ADDENDUM TO THE CONTRACT

Mendenhall Valley Public Library
Contract No. E14-051

ADDENDUM NO.: **TWO**

DATE ADDENDUM ISSUED: **March 20, 2014**

SHEET #
M1.2

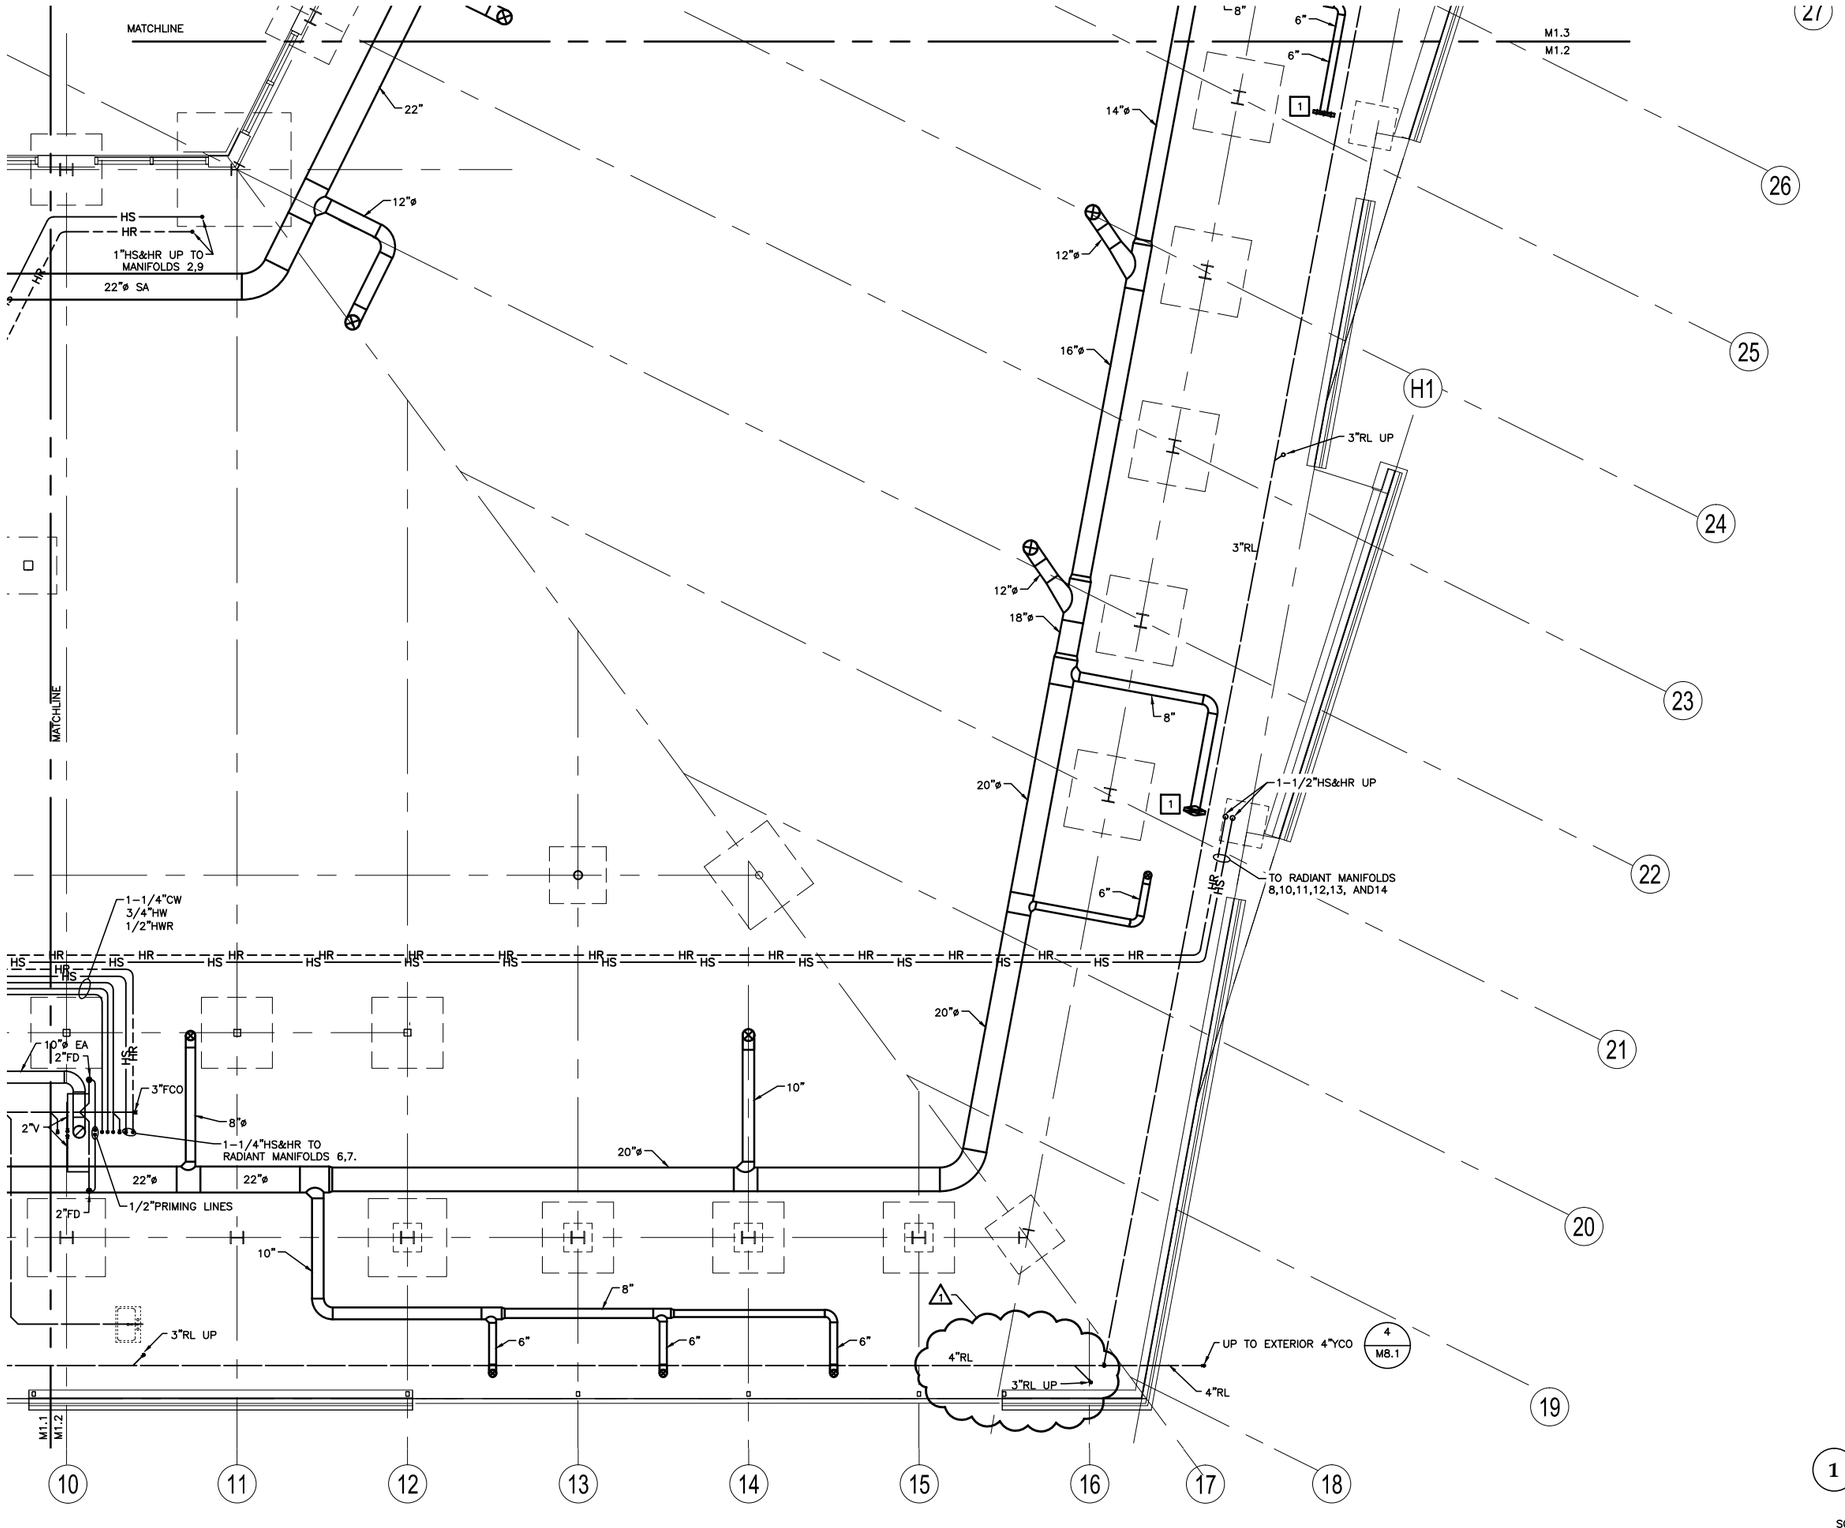
Delete M1.2 FOUNDATION PARTIAL PLAN B in its entirety and ***replace*** with the attached M1.2 FOUNDATION PARTIAL PLAN B, labeled Addendum No. 2 and dated March 19, 2014, for modified RL pipe routing.

SHEET # M2.2

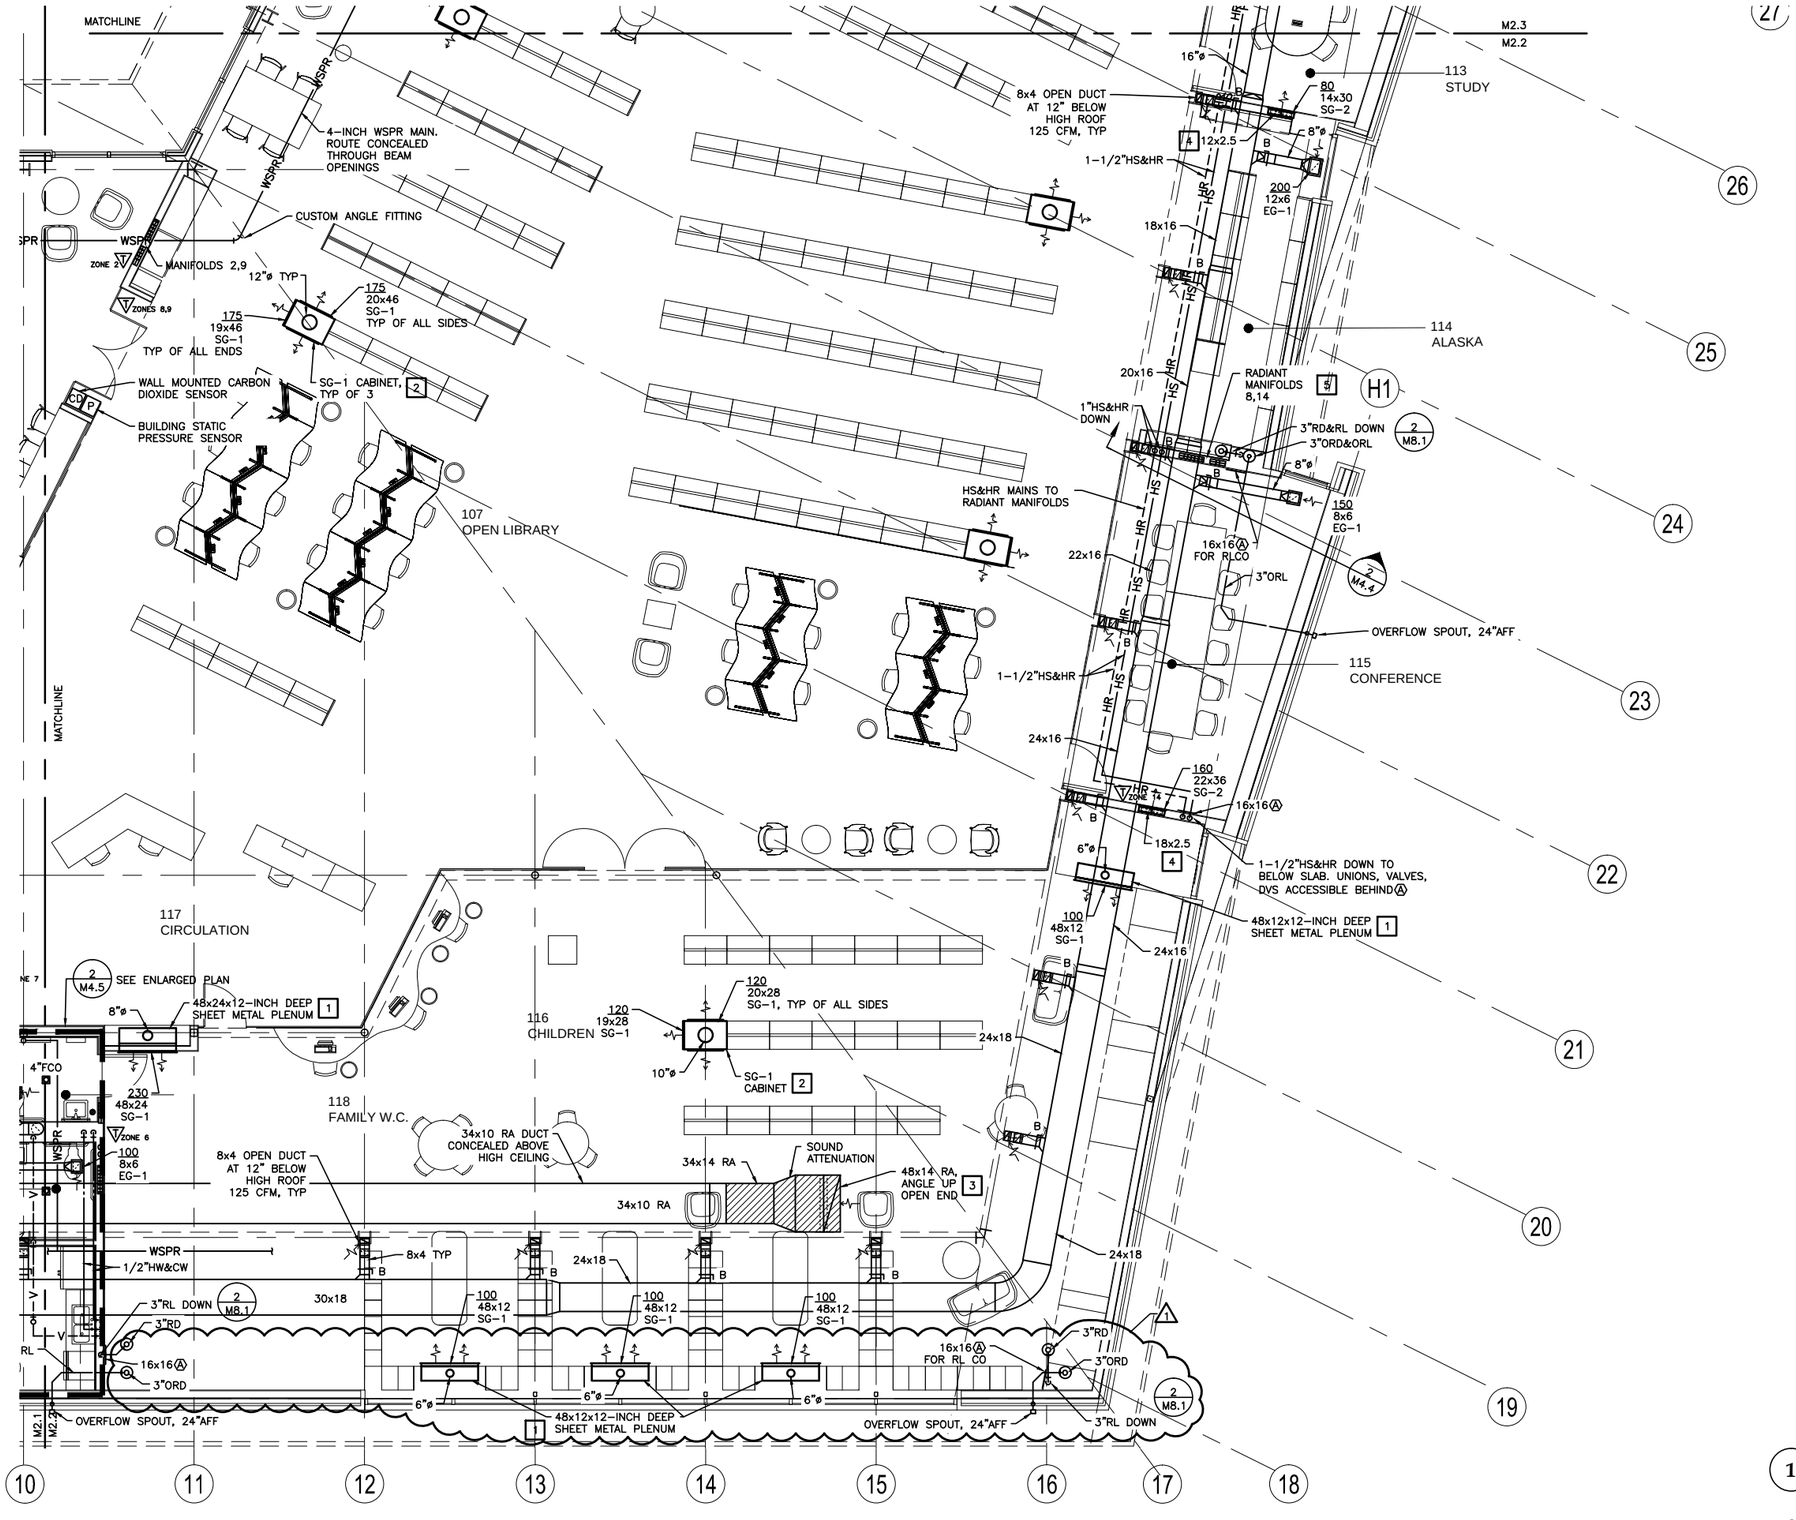
Delete M2.2 MAIN LEVEL PARTIAL PLAN B in its entirety and ***replace*** with the attached M2.2 MAIN LEVEL PARTIAL PLAN B, labeled Addendum No. 2 and dated March 19, 2014, for modified RL pipe routing.
